Site Accessibility Evaluation

IOOF Cemetery Trail

**711 S Carroll Blvd
Denton, TX 76201**

Accessibility Evaluation

Barrier: 1

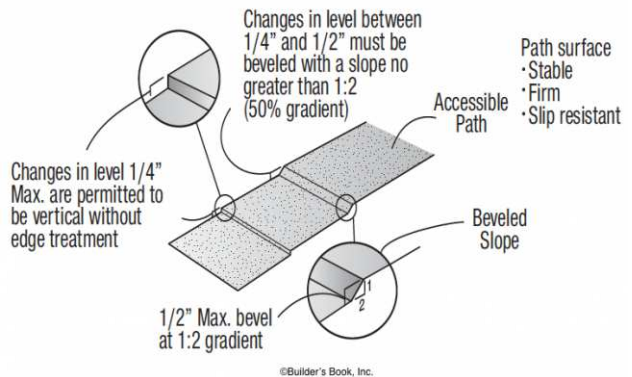
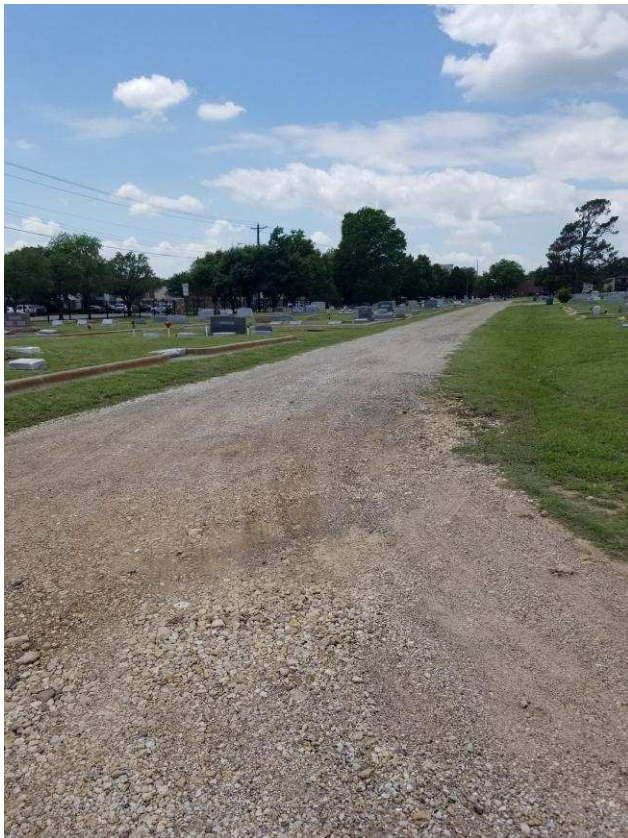
The accessible route contains loose gravel that does not provide for a stable, firm, slip-resistant surface.

2010 ADAS Section: 302.1

1991 ADAAG Section: 4.5.1

Provide a level, stable, slip-resistant ground surface as the path of travel.

Barrier: 2

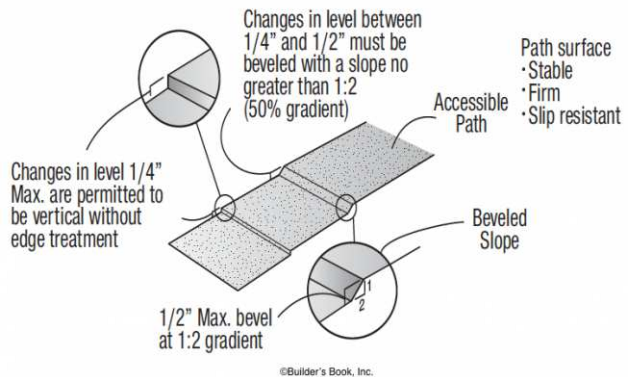
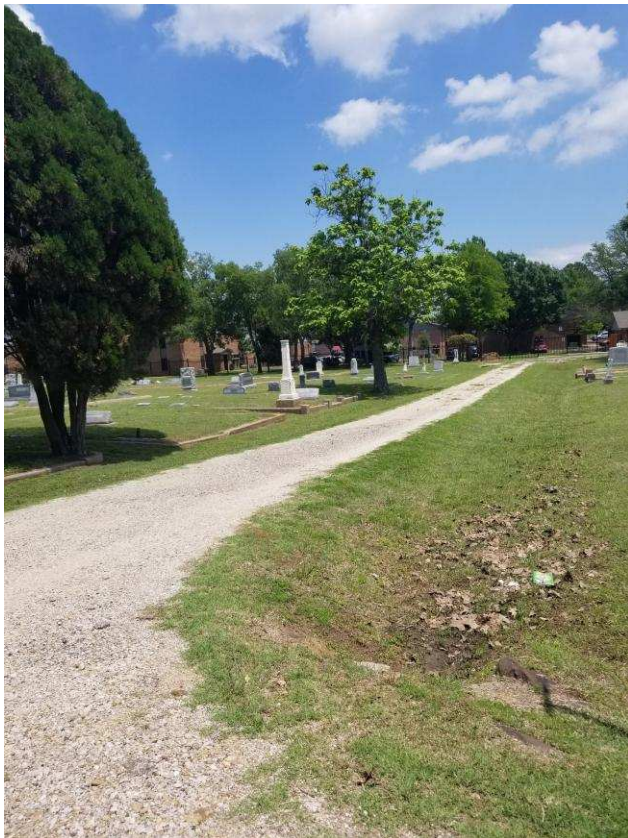
The accessible route contains loose gravel that does not provide for a stable, firm, slip-resistant surface.

2010 ADAS Section: 302.1

1991 ADAAG Section: 4.5.1

Provide a level, stable, slip-resistant ground surface as the path of travel.

Barrier: 2

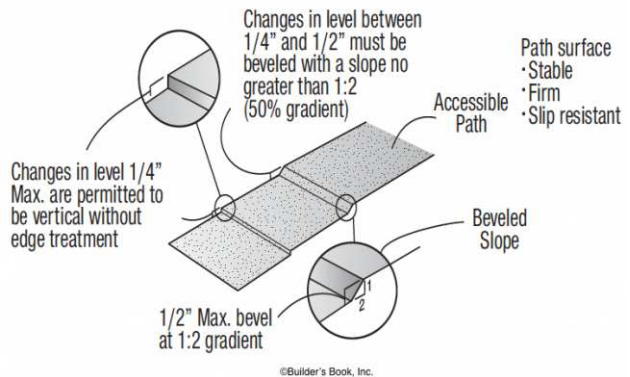
The accessible route contains loose gravel that does not provide for a stable, firm, slip-resistant surface.

2010 ADAS Section: 302.1

1991 ADAAG Section: 4.5.1

Provide a level, stable, slip-resistant ground surface as the path of travel.

Barrier: 3

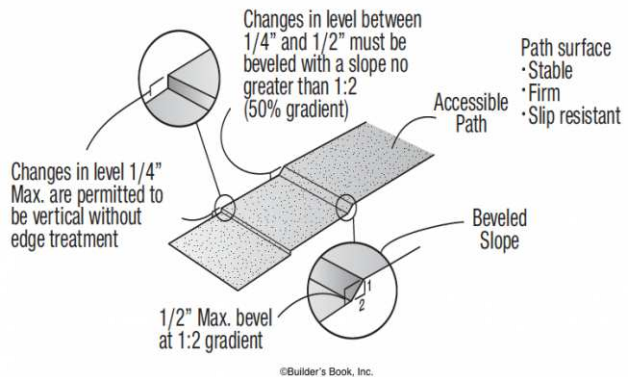
The accessible route contains loose gravel that does not provide for a stable, firm, slip-resistant surface.

2010 ADAS Section: 302.1

1991 ADAAG Section: 4.5.1

Provide a level, stable, slip-resistant ground surface as the path of travel.

Barrier: 1

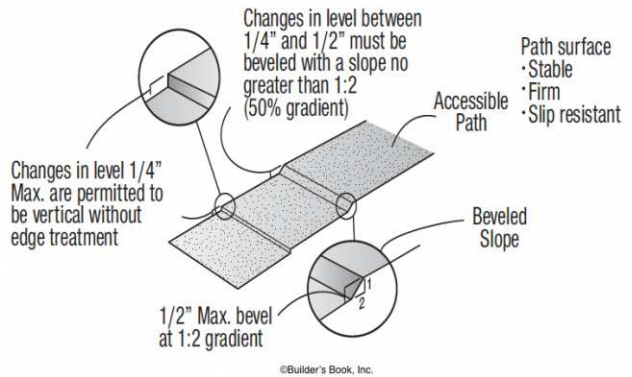
The trail contains loose gravel that does not provide for a stable, firm, slip-resistant surface.

2010 ADAS Section: 302.1

1991 ADAAG Section: 4.5.1

Provide a level, stable, slip-resistant ground surface as the path of travel to the trail head.

Barrier: 2

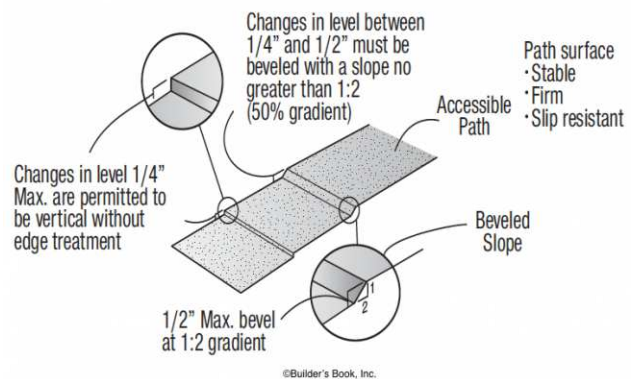
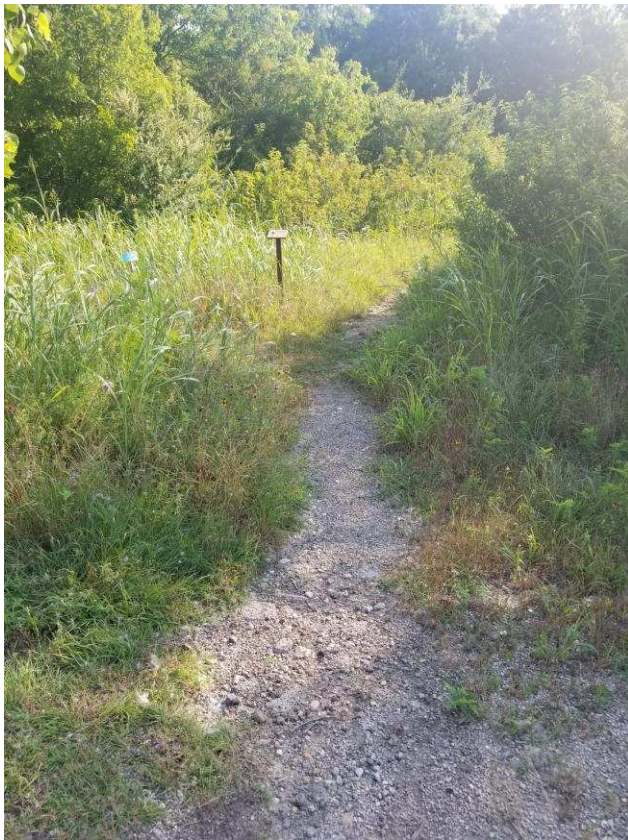
The trail contains loose gravel that does not provide for a stable, firm, slip-resistant surface.

2010 ADAS Section: 302.1

1991 ADAAG Section: 4.5.1

Provide a level, stable, slip-resistant ground surface as the path of travel to the trail head.

Barrier: 3

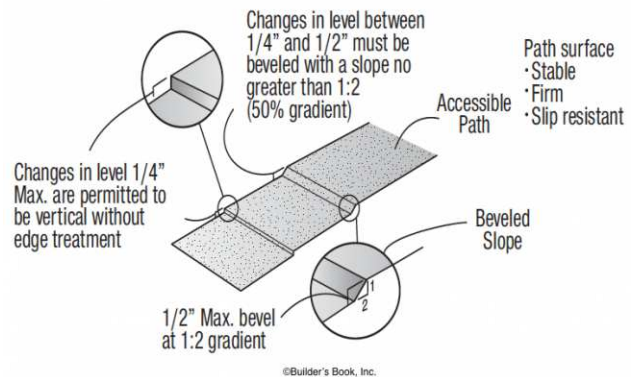
The trail contains loose gravel that does not provide for a stable, firm, slip-resistant surface.

2010 ADAS Section: 302.1

1991 ADAAG Section: 4.5.1

Provide a level, stable, slip-resistant ground surface as the path of travel to the trail head.

Barrier: 4

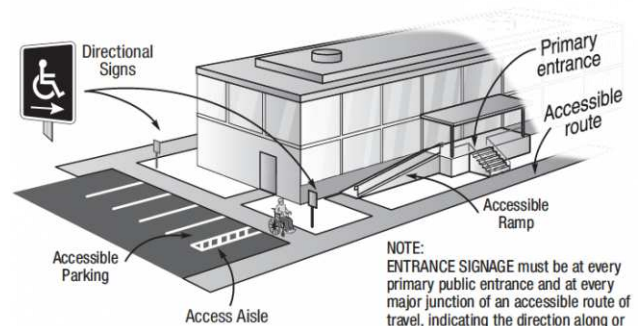
There is no accessible route to the trash can.

2010 ADAS Section: 206.2.2

1991 ADAAG Section:
4.1.2(1)

Relocate trash can closer to an accessible path of travel.

Barrier: 6

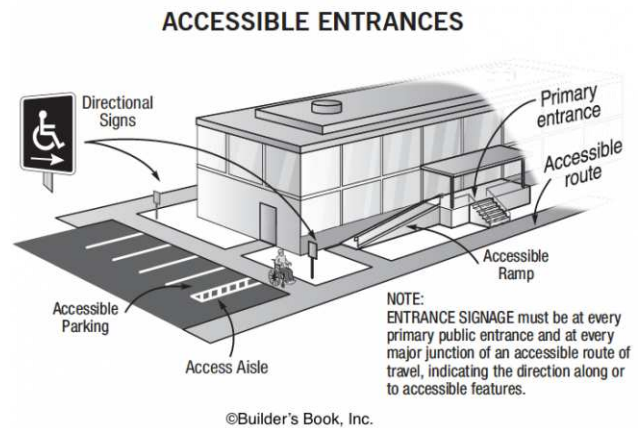
There is no accessible route to the portable restroom.

2010 ADAS Section: 206.2.2

1991 ADAAG Section:
4.1.2(1)

Provide an accessible route of travel to the portable restroom.

Barrier: 7

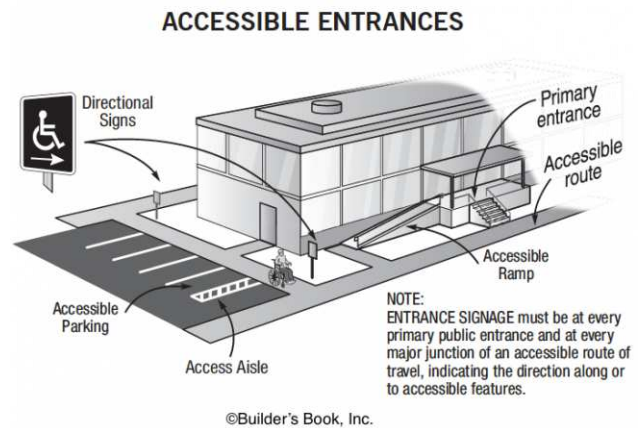
There is no accessible route to the trail maps.

2010 ADAS Section: 206.2.2

1991 ADAAG Section:
4.1.2(1)

Provide an accessible route of travel with a stable, firm, slip-resistant surface to the trail maps.
